PHAP18-00010

Date: April 2, 2018
Application Type: Certificate of Appropriateness
Property Owner: Stephanie Nebhan
Representative: Stephanie Nebhan.
Legal Description: 99 Government Hill 22 & 23 & pt. of 20 & 21 (78.65 Ft on S. 141.85 ft. on W 55.08 ft. on N. 140 ft. on E.), City of El Paso, El Paso County, Texas
Historic District: Austin Terrace
Location: 4519 Trowbridge Drive
Representative District: #2
Existing Zoning: R-4/H (Residential/Historic)
Year Built: 1925
Historic Status: Contributing
Request: Certificate of Appropriateness for alterations to the front yard including artificial turf, landscaping, steps, lighting, and new walls
Application Filed: 3/19/2018
45 Day Expiration: 5/3/2018

ITEM #2

Certificate of Appropriateness for alterations to the front yard including artificial turf, landscaping, steps, lighting, and new walls

PROPOSED PLAN

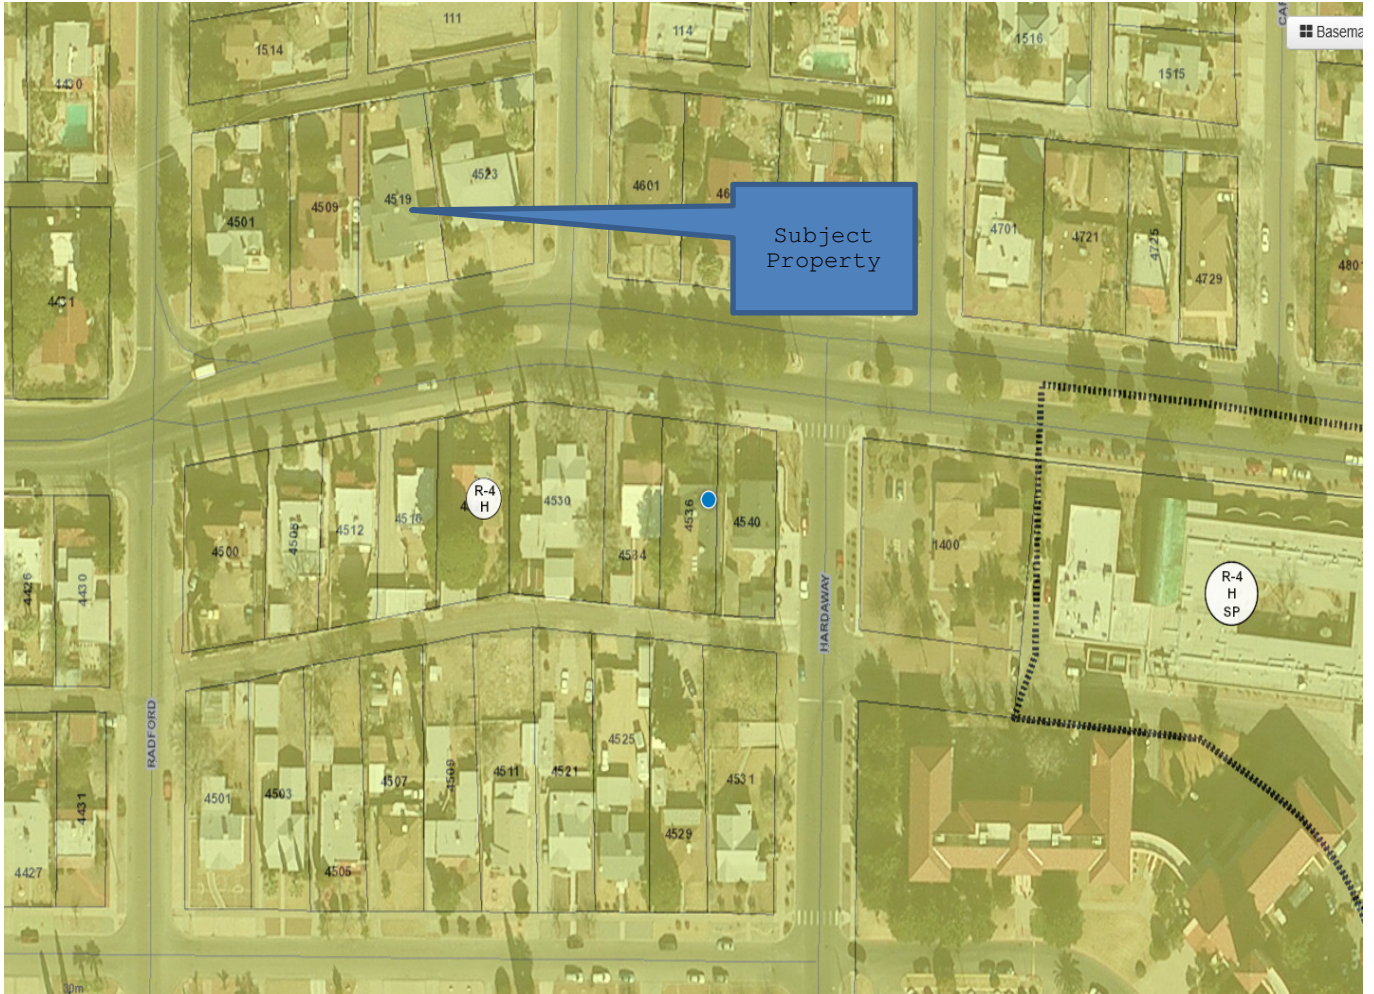
The modifications are that a cut sheet of the exact lighting fixture be submitted to staff before permits are requested, that the light fixtures be placed in a location closer to the house itself and not on the front property line, and that the artificial turf be replaced with live plants or grass.
